**TOWN OF COTTAGE GROVE  
PLAN COMMISSION  
RESOLUTION 2024-10-23a**

**RECOMMENDING CONDITIONAL APPROVAL OF THE  
PRELIMINARY PLAT OF KENNEDY HILLS FIRST ADDITION**

# PRELIMINARY PLAT OF KENNEDY HILLS FIRST ADDITION

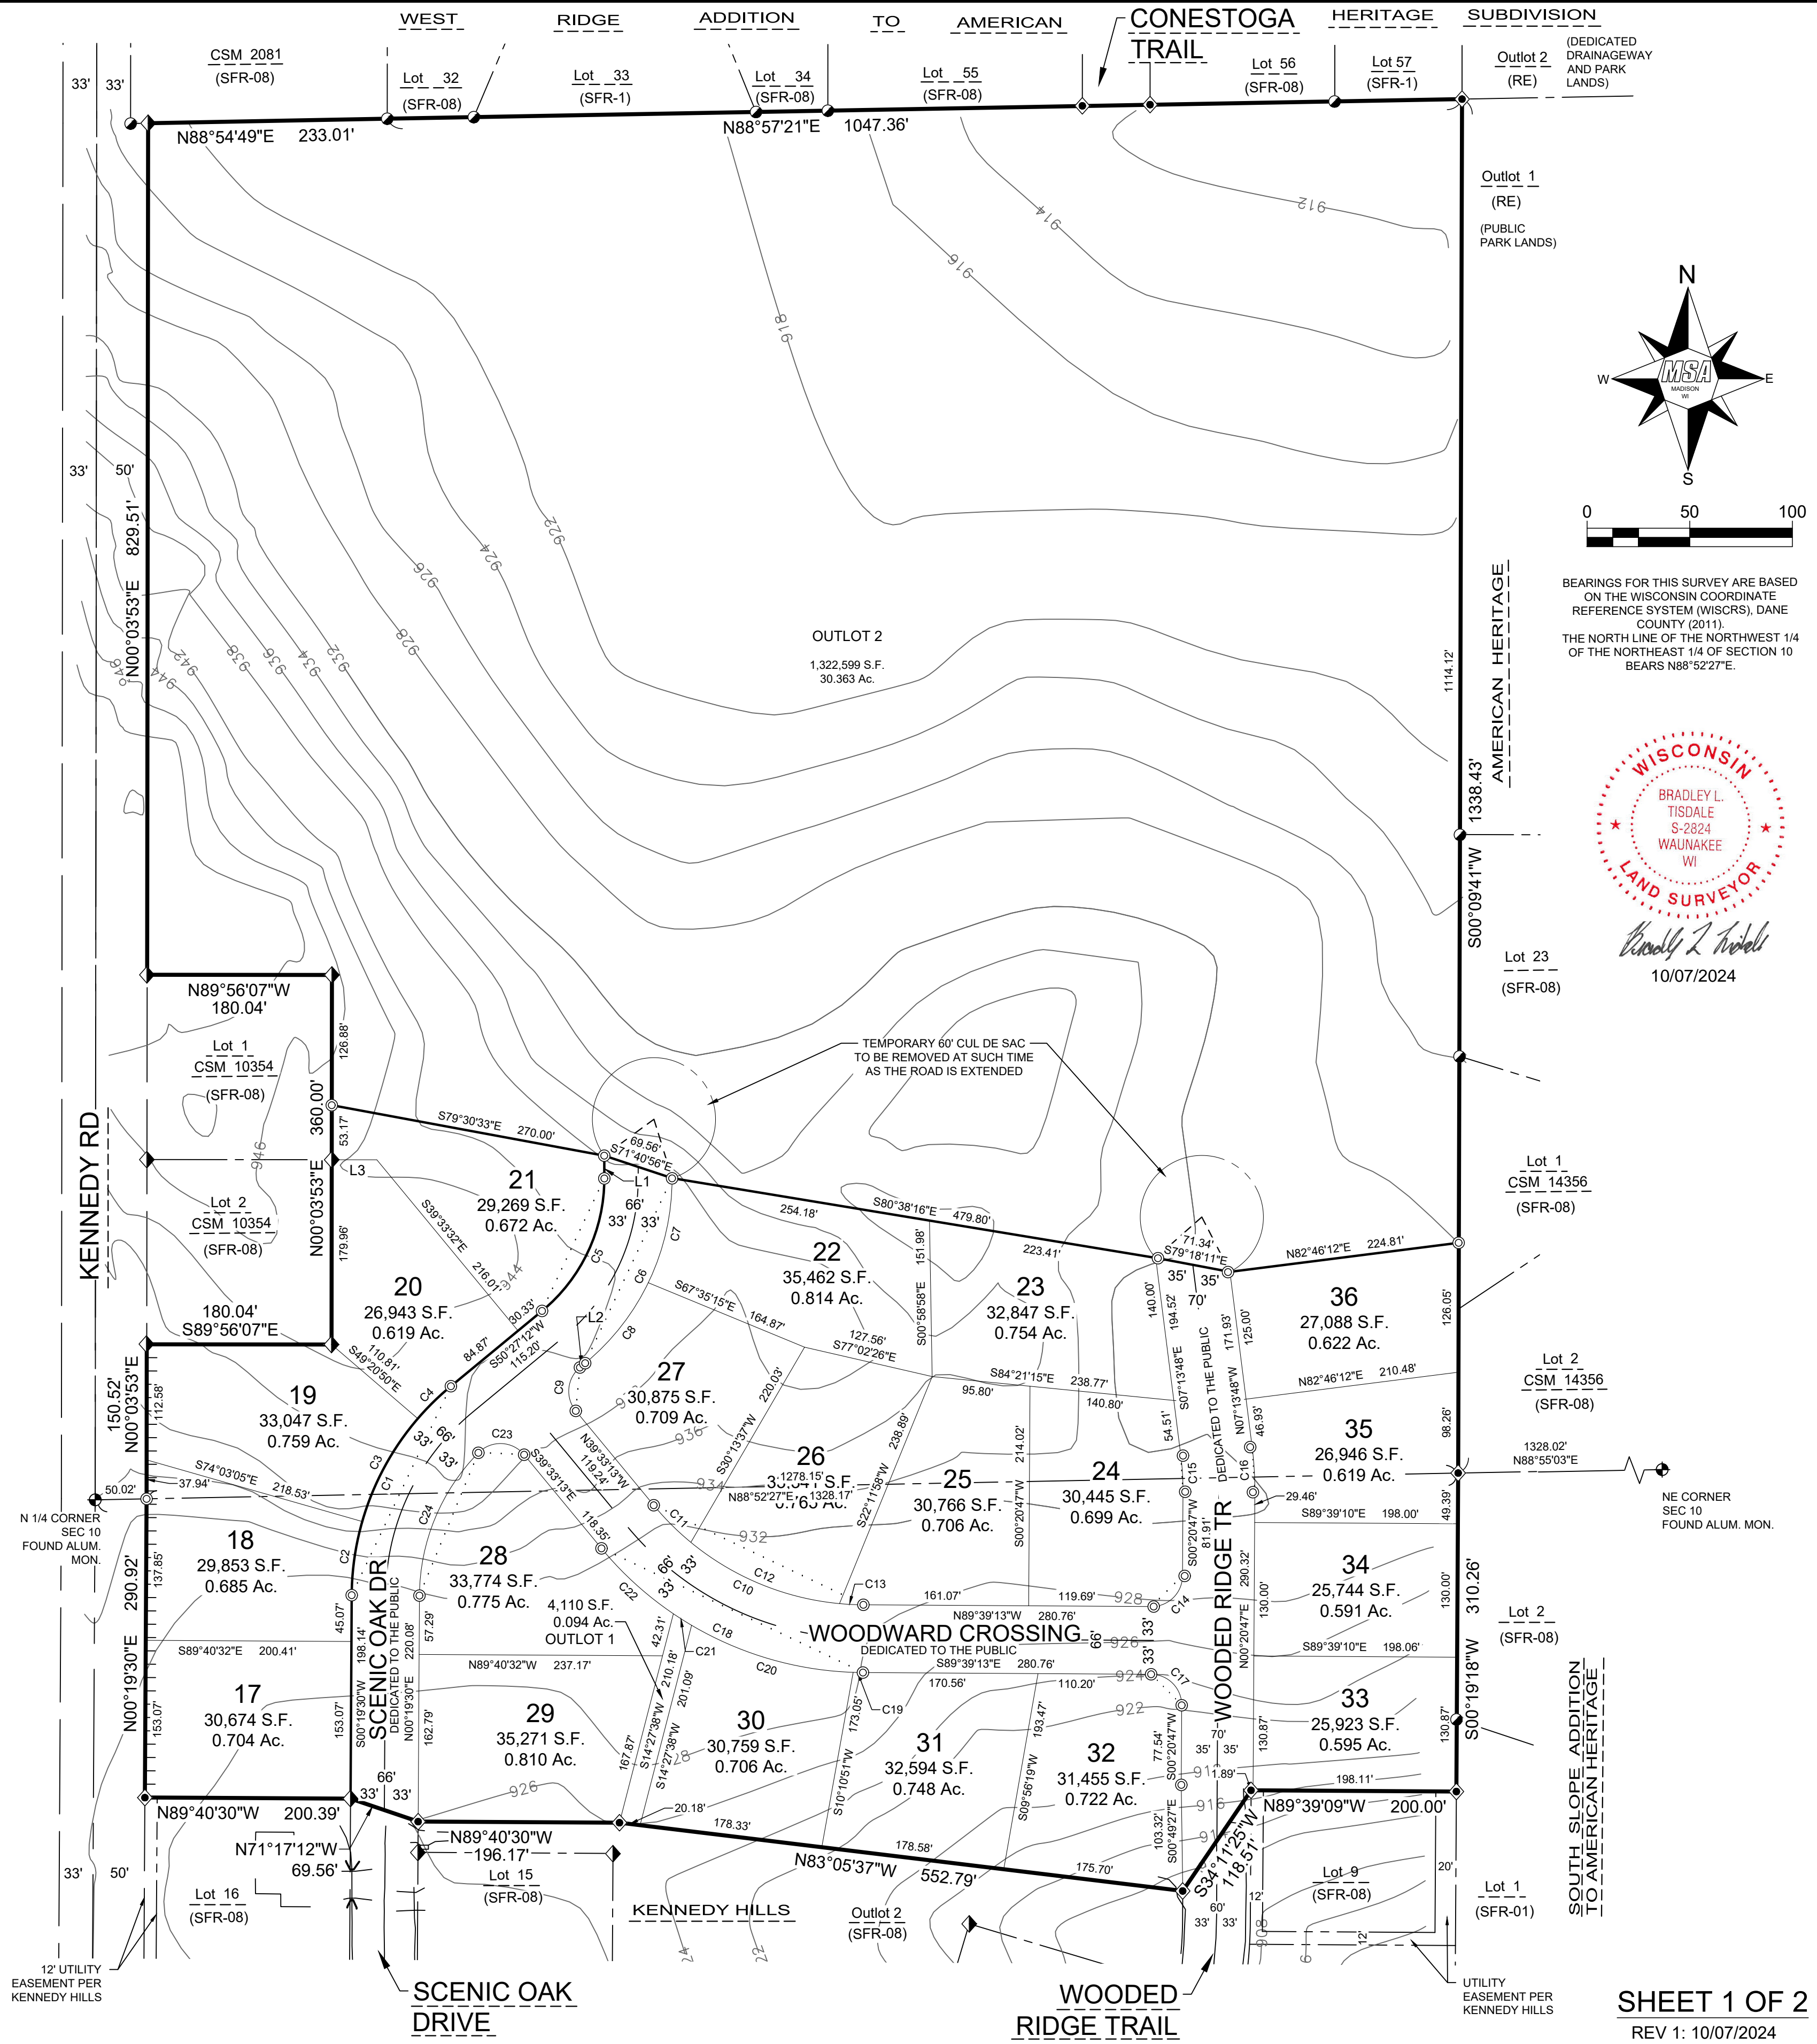
- i. The Developer shall replace on the preliminary plat and engineering plans the current cul-de-sac bulb at the northern terminus of current Wooded Ridge Trail with a hammerhead turnaround within the dedicated right-of-way, of a design approved by the Town Engineer.

- NOTE:
- OUTLOT 1 IS DEDICATED FOR TRAIL/PARK ACCESS PURPOSES
  - OUTLOT 2 IS PLANNED FOR FUTURE PLATTING PHASES
  - EACH LOT OWNER SHALL BE OBLIGATED TO PAY PARK IMPACT FEES TO THE TOWN OF COTTAGE GROVE AT THE TIME A BUILDING PERMIT IS ISSUED FOR THEIR LOT.
  - ACCESS RESTRICTION: NO DIRECT VEHICULAR ACCESS TO LOTS 17-19 FROM KENNEDY RD.
